**ADDENDUM NO. 2 TO PROJECT NO. Q1594
CONSTRUCTION WORK
REHABILITATE, REPAVE AND SEAL
FACILITY PAVING AREAS
SYRACUSE ARMORY
6900 THOMPSON ROAD
SYRACUSE, NY 13211**

August 27, 2014

CONTRACT: CONSTRUCTION
TITLE: REHABILITATE, REPAVE AND SEAL FACILITY PAVING AREAS
LOCATION: SYRACUSE ARMORY
6900 THOMPSON ROAD
SYRACUSE, NEW YORK 13211
CLIENT: NEW YORK STATE
DIVISION OF MILITARY
& NAVAL AFFAIRS

1"=40'		
1	8/26/2014	ADDENDUM NO. 2
0	6/26/2014	FINAL SUBMISSION
PROJECT NUMBER:	Q 1594	
DESIGNED BY:	R. DUFF	
DRAWN BY:	D. KENT	
FIELD CHECK:		
APPROVED:		
SHEET TITLE:	SITE PLAN THOMPSON ROAD & POV PARKING LOT	
DRAWING NUMBER:	C-102	
SHEET	4	OF 9

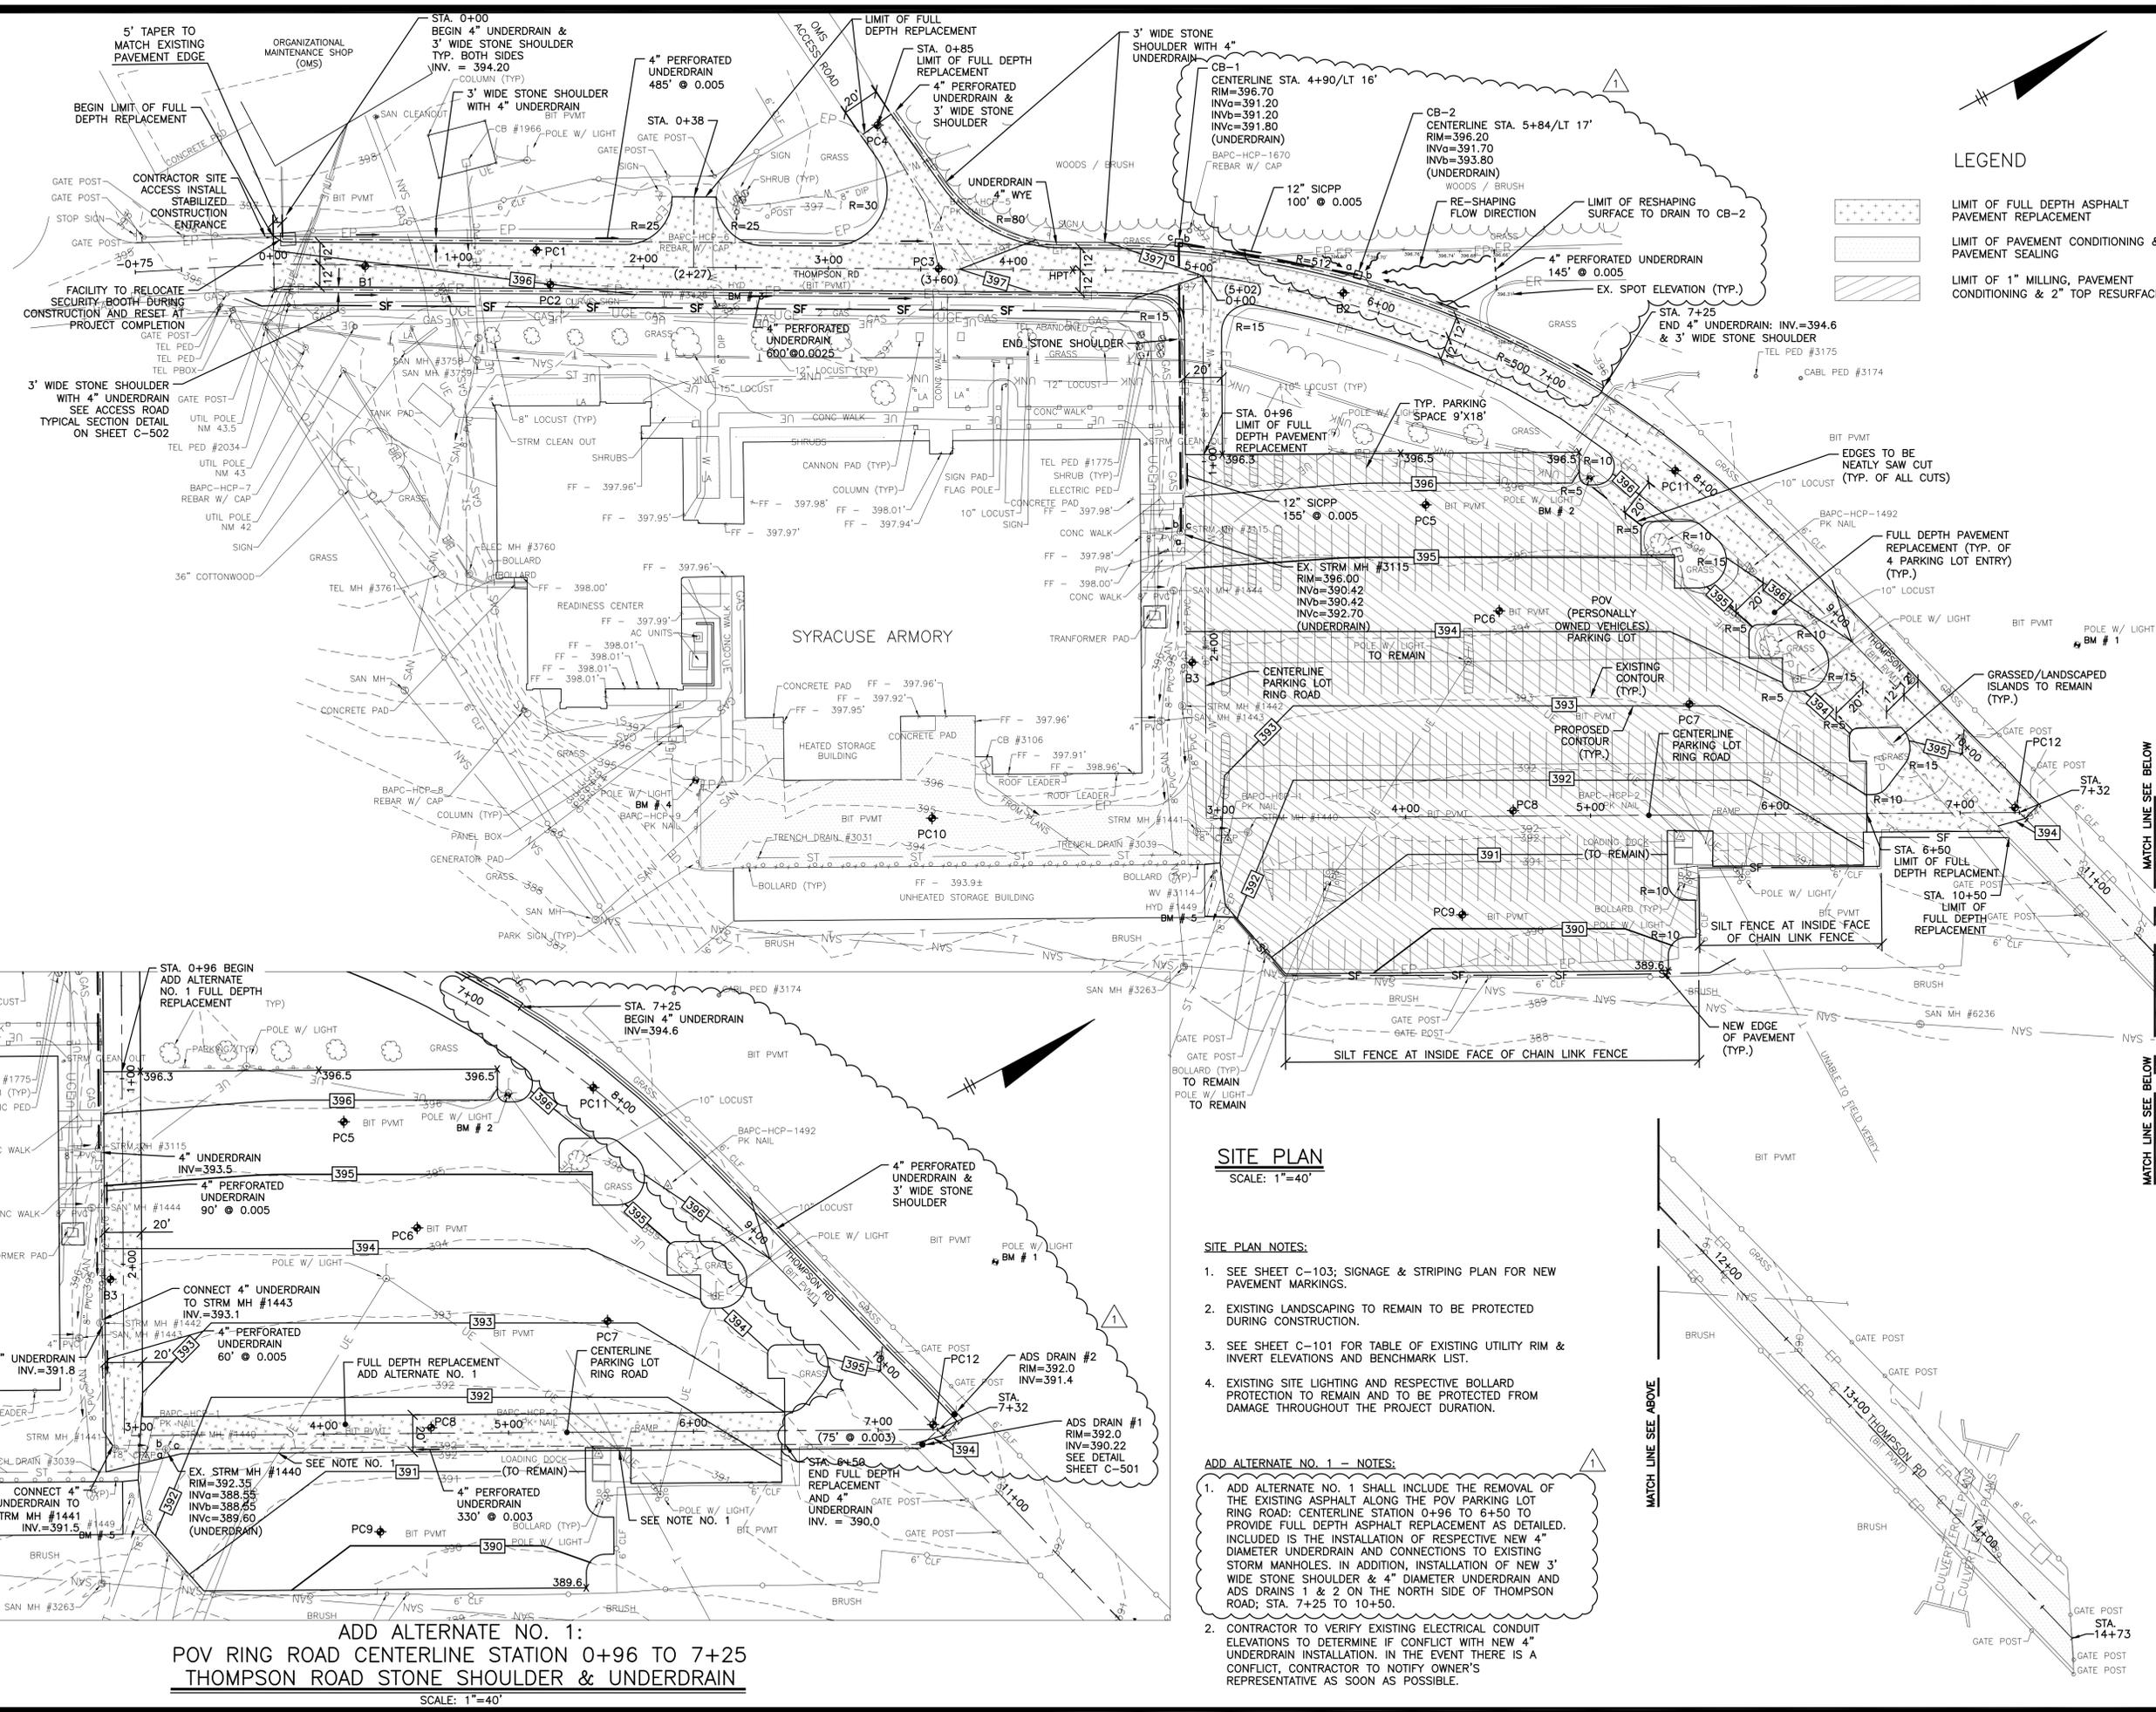
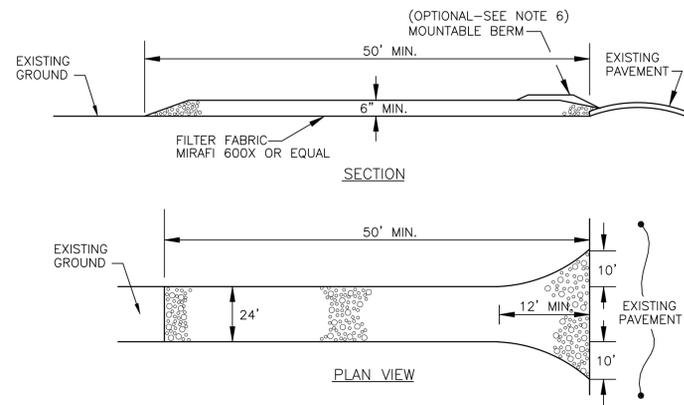
1. REVISIONS to Drawing No. C-102 (copy attached):
 - a. ADDED additional information re: Thompson Road centerline station 5+00 to 7+00;
 - Station off-sets for CB-1 & 2
 - Added existing spot elevations north side of roadway
 - b. ADD ALTERNATE No. 1
 - ADDED Additional 4" diameter underdrain on POV Ring Road and along north side of Thompson Road
 - ADDED Additional 3' wide stone shoulder along north side of Thompson Road; Station 7+25 to 10+45
 - c. REVISED Add Alternate No. 1 Notes; Note Number 1
2. REVISION to Drawing No. C-501 (copy attached):
 - a. ADDED ADS Drain Basin Detail
3. REVISIONS to Drawing No. C-502 (copy attached):
 - a. ADDED additional Add Alternate No. 1 information to following details; "UNDERDRAIN" and "ACCESS ROAD (THOMPSON ROAD)-TYPICAL SECTION-NORMAL CROWN"
